DAHLIA SOLAR PROJECT SPECIAL USE PERMIT APPLICATION SUPPLEMENT

Cochise County Planning and Zoning Division
1415 Melody Lane, Building F – Bisbee, Arizona 85603

August 21, 2024

Table 1. Response to Additional Project Comments

Exhibit 1. Revised Concept Site Plan

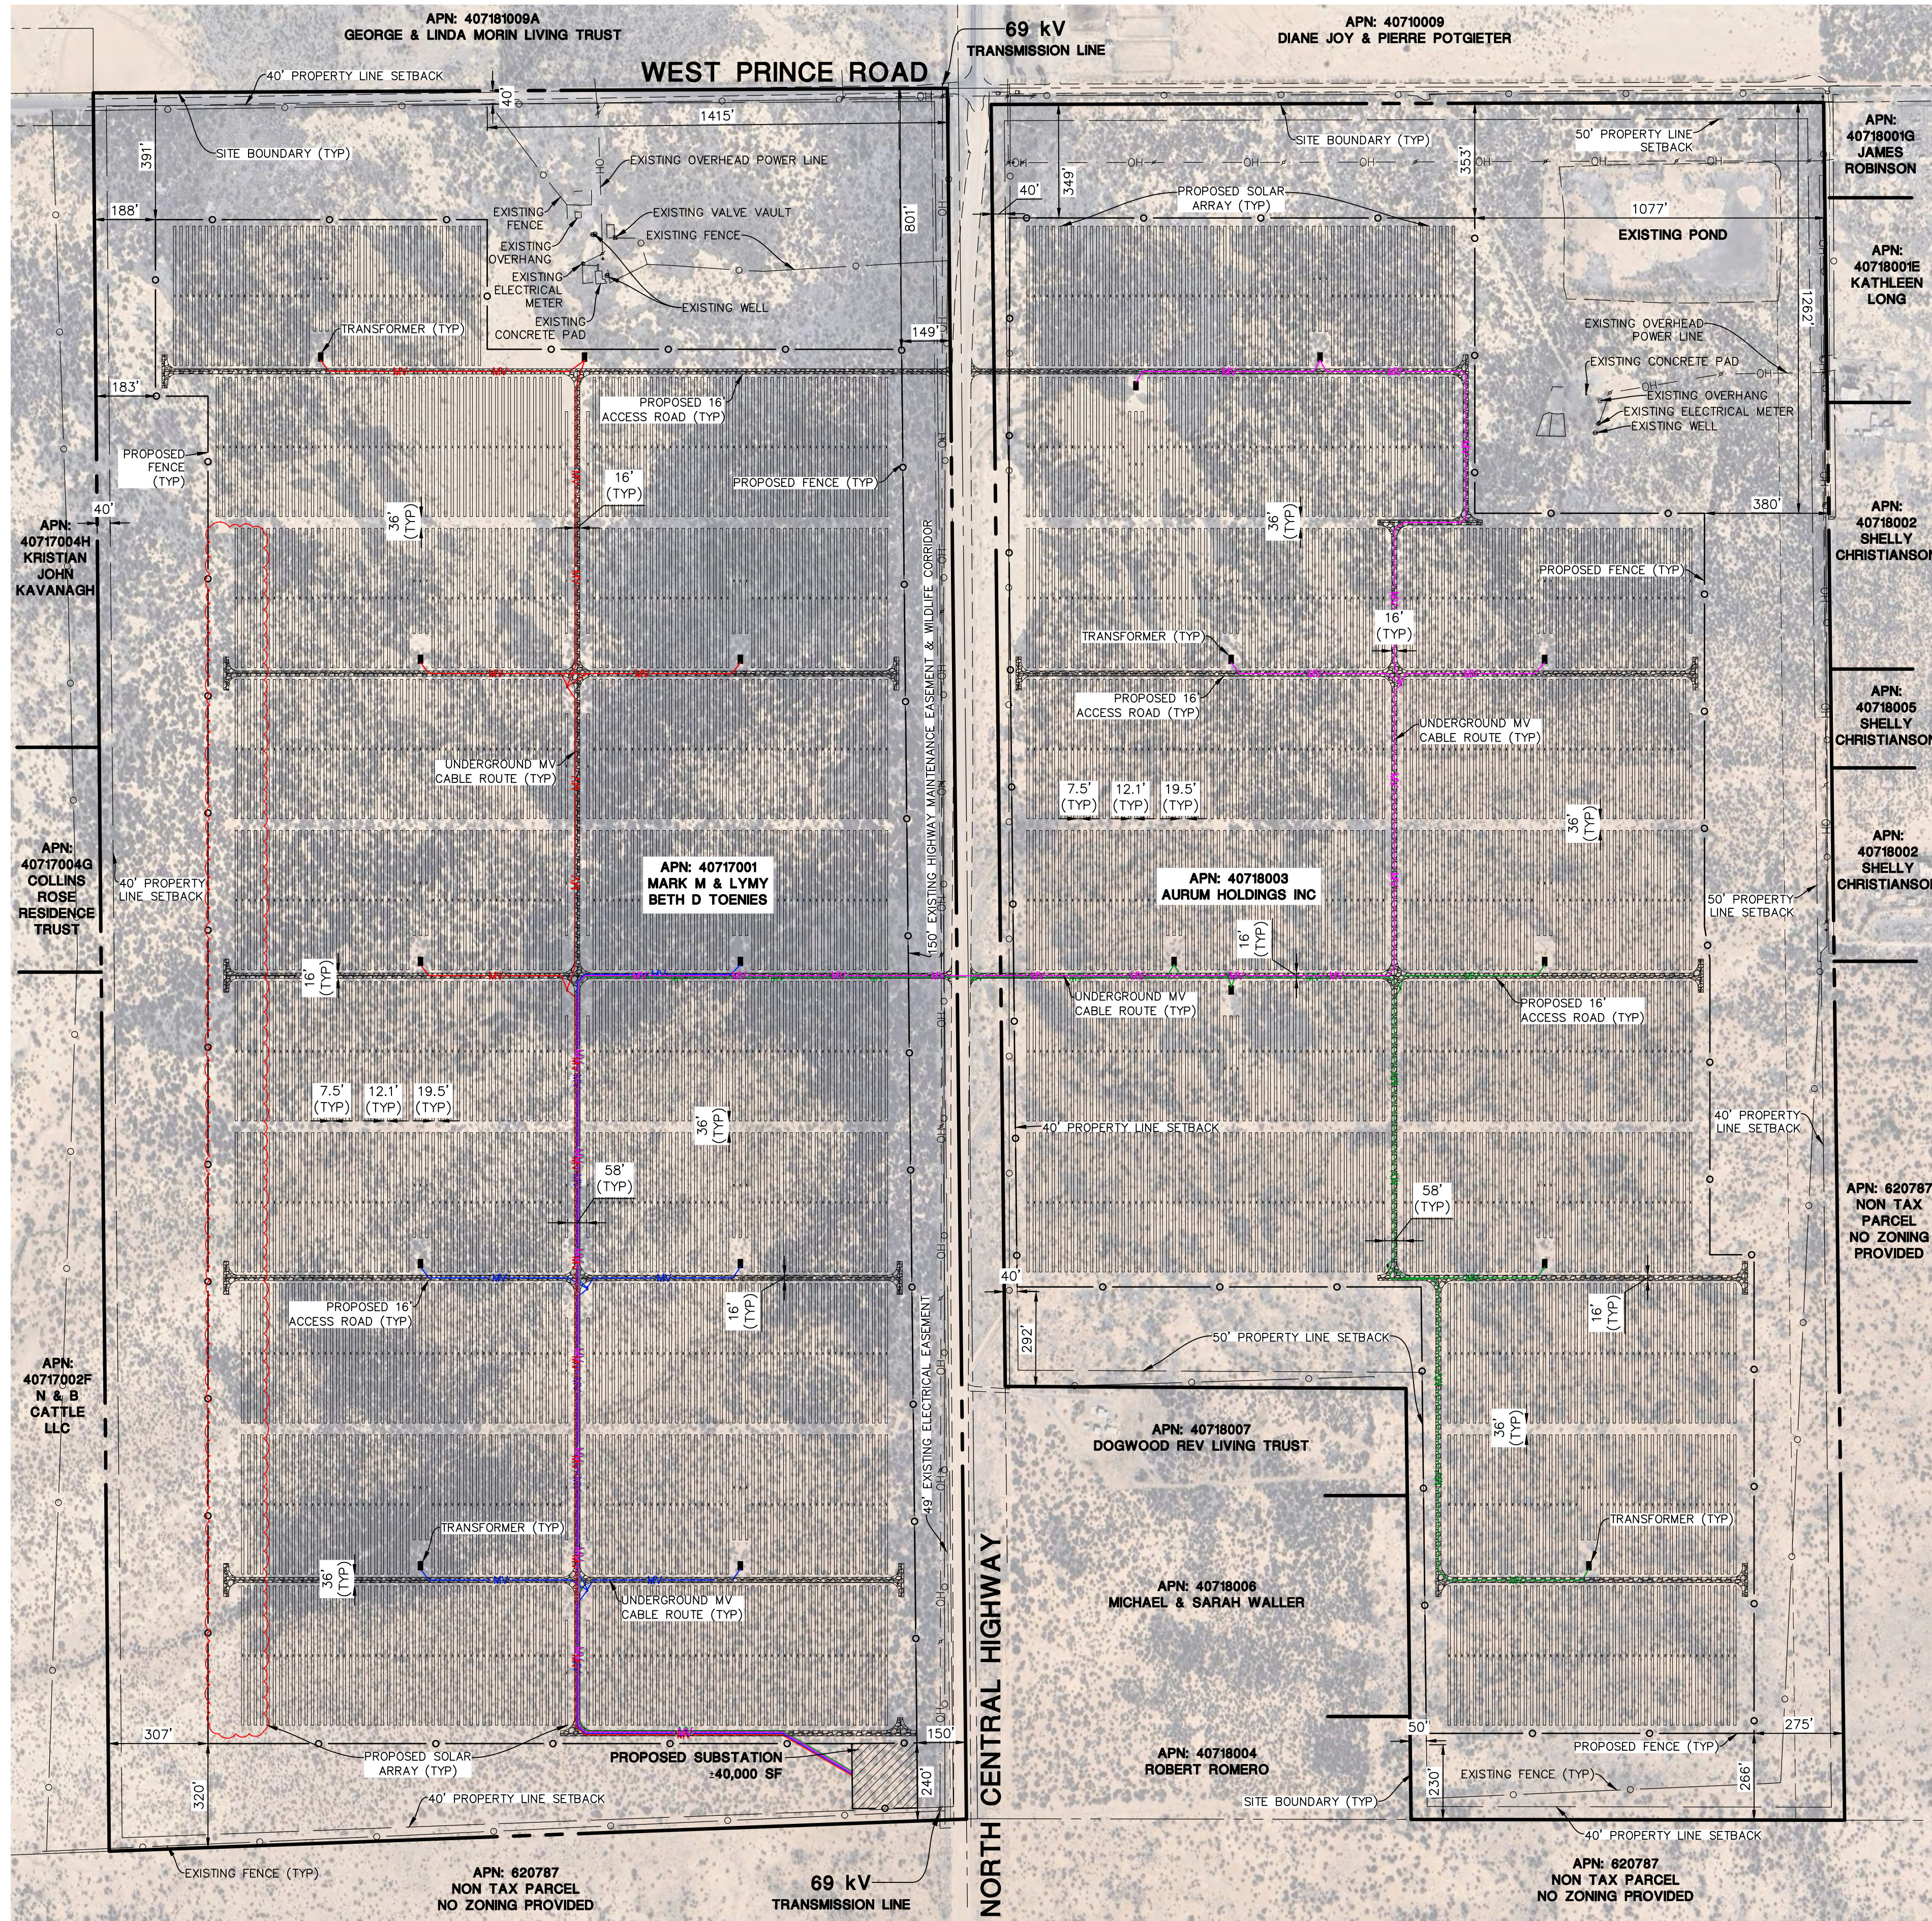
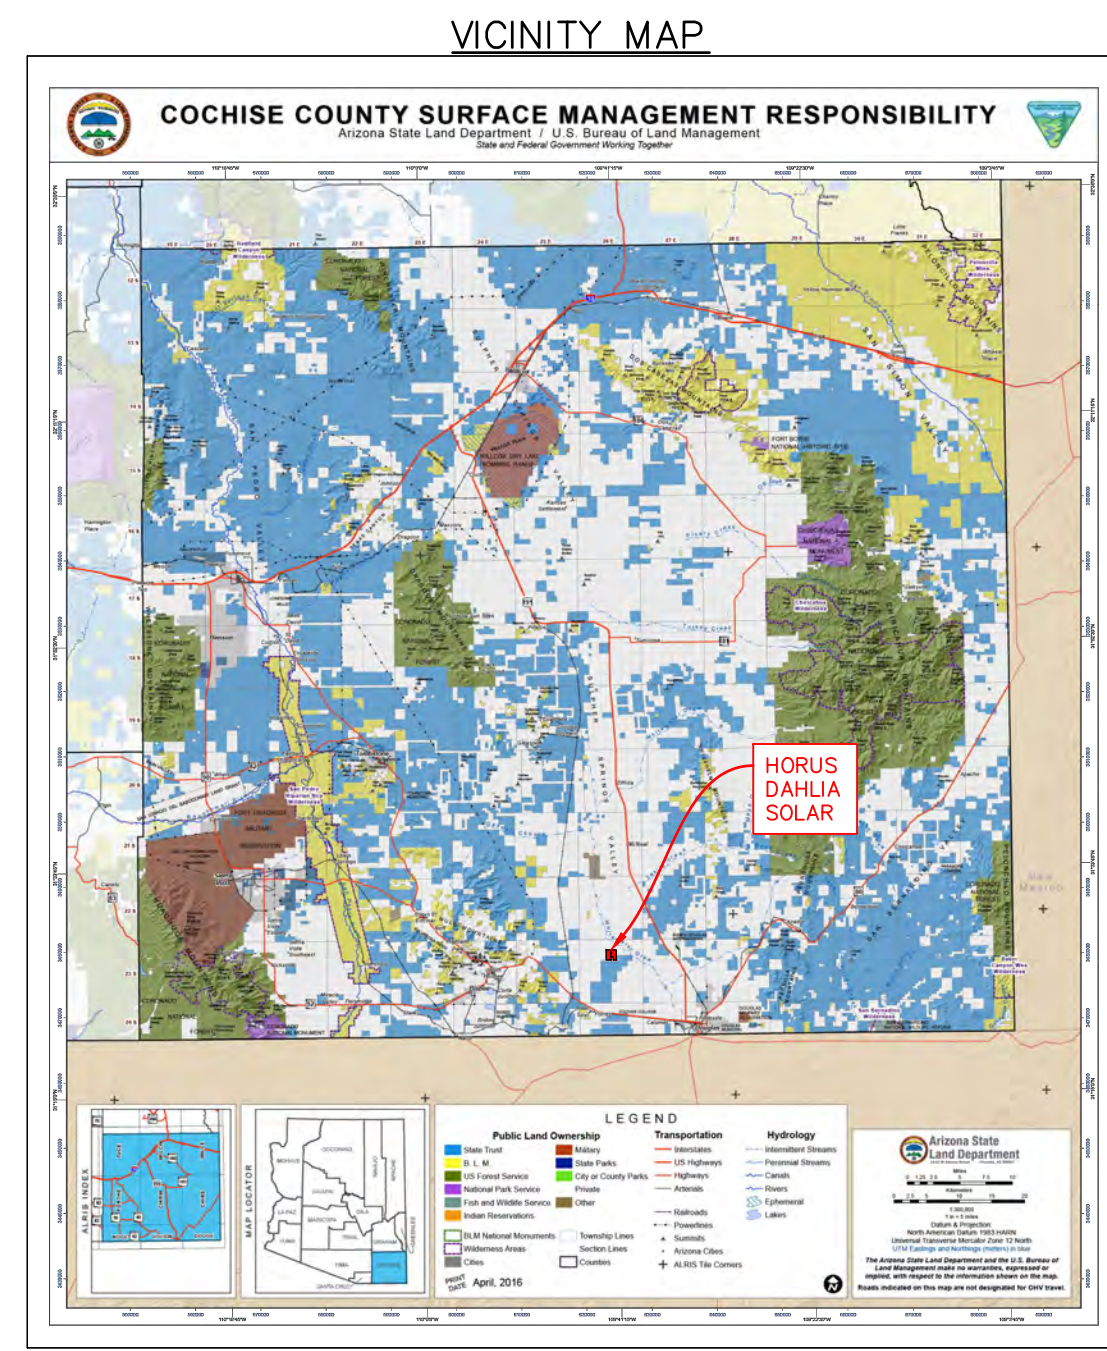
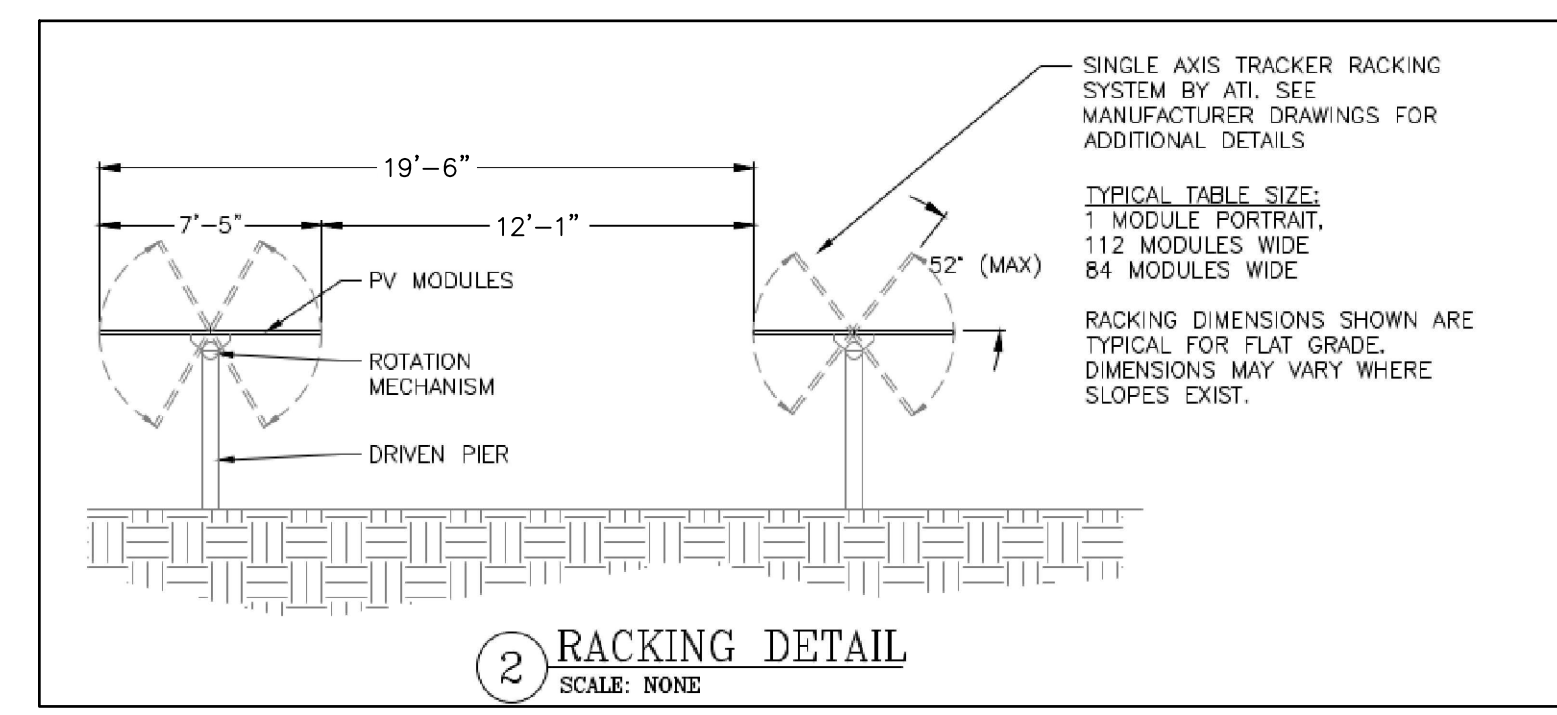
Comment	Response
3.1. Requested Conditions	
Minimum of 300 ft buffer/ wildlife corridor is requested between the Project boundary and Mule Deer Place.	The northeast corner of the Project site preserves open space which has been expanded from 906 feet wide to 1,073 feet wide. The remaining open space corridor along Mule Deer Place was expanded to approximately 380 feet wide in response to comments. South of Mule Deer Place, the east open space corridor will be approximately 265 feet wide.

The Concept Site Plan has been revised (**Exhibit 1**) in response to public engagement. The undeveloped open space along the Project perimeter has been further expanded to provide increased wildlife connectivity and open space to minimize visual impacts for existing and future neighbors. The Applicant directed project engineers to revisit the layout after the Special Use Permit application was submitted and tighten the spacing between the panels to provide additional open space setbacks along the perimeter of the Project while 1) preserving the functionality of the panels and 2) complying with the Arizona Game and Fish Department (AGFD) recommended panel spacing specifications to install racks at a low ground cover ratio and space tracker rows no less than 12 feet apart. Concept Site Plan updates include the following:

- The distance between the outer edge of the panels was previously 14 feet, 6 inches from panel edge to panel edge. It is now 12 feet, 1 inch. The low ground cover ratio was also preserved, changing from 34 to 38 percent. Although the panels were spaced more closely together, this is still within the recommendations for panel spacing provided by AGFD.
- Open space/wildlife corridor width was increased significantly along the west and north boundary of west parcel and the east boundary of the east parcel. **Exhibit 2** (Project Limits) provides a comparison of the layout boundaries from the previous Concept Site Plan and the revised Concept Site Plan.
- There are large, open space areas preserved on the northeast corner of both the eastern and western parcels. The large open space area on the northeast corner of the eastern parcel was

increased along with modest increases to the north and south open space corridors of the eastern parcels as well.

**Exhibit 3. Davis Monthan Air Force Base Relative
to Photovoltaic Solar Generation Sites**

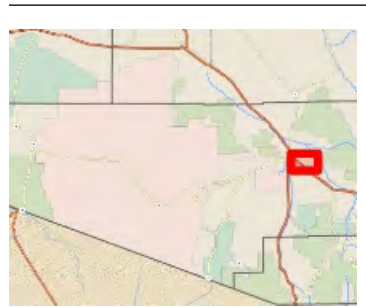
<p>3.5. Health and Safety</p>	
<p>There are airports located in the vicinity of the Project site. Will the Project compromise safety of aircraft due to glare?</p>	<p>Modern solar panels incorporate low-glare technology into the panels. Spacing the solar panel rows also breaks up the potential for glare. Solar panels are designed to capture, and not reflect, as much light as possible. Glass from solar panels can produce some glare; however, studies indicate that the potential glare from solar arrays is comparable to glare from a body of smooth water and modern PV panels reflect as little as two percent of incoming sunlight, which is about the same as water and less than soil or even wood shingles.⁷ The Applicant is coordinating with the Dept. of Defense Military Aviation and Installation Assurance Siting Clearinghouse and intends to file an obstruction evaluation/airport airspace analysis (OE/AAA) with the Federal Aviation Administration regarding the Project. These entities will then evaluate the Project in connection with aviation. Fort Huachuca has two utility scale solar developments located at the base, just two miles from the runway. Solar project summaries are available on Tucson Electric Power’s website: https://www.tep.com/fort-huachuca-phase-ii/ and https://www.tep.com/fort-huachuca-phase-i/. Davis Monthan Airforce Base in Tucson has multiple solar installations at and near the base on the north, west and south sides of the runway (Exhibit 3).</p>
